Contract #: 04-0120F4Cty: SF/ALA Rte: 80 PM: 13.2/13.9File #: 69.25B**QUALITY ASSURANCE -- NON-CONFORMANCE REPORT****Location:** Changxing Island, Shanghai, P.R. China**Report No:** NCR-000239**Prime Contractor:** American Bridge/Fluor Enterprises, a JV**Date:** 25-Mar-2009**Submitting Contractor:** Zhenhua Port Machinery Company, Ltd (ZPMC), Changxing Island**NCR #:** ZPMC-0213**Type of problem:****Welding****Concrete****Other****Welding****Curing****Procedural****Bridge No:** 34-0006**Joint fit-up****Coating****Other****Component:** OBG U-Rib Deck Panels**Procedural****Procedural****Description:****Reference Description:** Deck panel distortion due to excessive welding repair**Description of Non-Conformance:**

Job Name: SAS Superstructure

Subject: NCR No. ZPMC-0213

Reference Description: Deck panel distortion due to excessive welding repair

Draft of welding discontinuity:

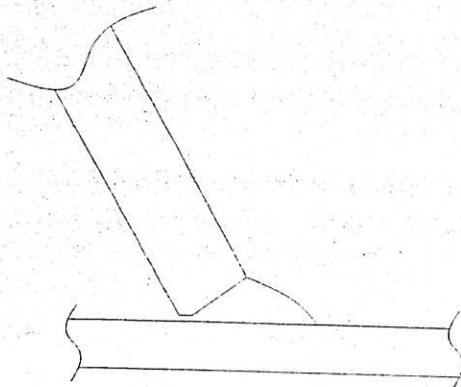
CT对顶板板单元DP442-001,DP332-002,DP492-001,DP249-001,DP305-001,DP357-001,DP495-001,DP469-001,DP330-002,DP415-001 PAUT检测时发现裂纹。

Caltrans found crack at DP442-001,DP332-002,DP492-001,DP249-001,DP305-001,DP357-001,DP495-001,DP469-001,DP330-002,DP415-001 by use of PAUT.

1. 焊道未及时处理干净。
1. Did not clear the weld pass completely in time.

1. 利用打磨的方法去除裂纹;
 2. 按照焊接返修工艺规程(WPS)准备焊缝接头形式;
 3. 返修前对坡口作100%VT与MT检查, 确保缺陷完全去除;
 4. 按照批准的焊缝返修工艺规程(WPS)进行预热和焊接修补;
 5. 打磨焊缝区域使其与邻近焊缝平齐;
 6. 对修补区域作100%VT与MT检测;
-
1. Remove the defects by means of grinding cleanly.
 2. Prepare excavation in accordance with an approved repair WPS.
 3. Perform VT and MT to the groove to ensure the removal of the defects before repairing.
 4. Preheat and weld according to the relevant repair WPS.
 5. Grind the weld flush with adjacent welds.
 6. Perform 100% VT and MT to the repair area.

Deck Panel 442-001 showing weld/base metal repair area of crack excavation area.

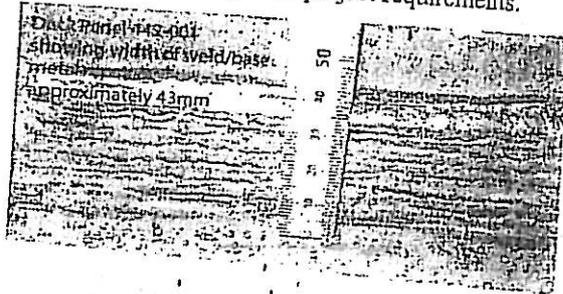
Caltrans Quality Assurance (QA) Inspector observed ZPMC welders performing base metal repairs on closed ribs of the deck panels. The repairs were located above the excavated cracks on the PJP weld joint for DP442-001, DP332-002, DP492-001, DP249-001, DP442-001, DP305-001, DP357-001, DP495-001, DP469-001, DP330-002, and DP415-001.

QA Inspector observed excessive welding on these repair area. Shortly after the welding, QA Inspector also noted the distortion of the deck panels. Also, QA Inspector confirmed with ZPMC QC Inspector Mr. Sun Bo that the repairs were done without an approved base metal repair procedure. These welding repairs were not performed according to the project requirements.
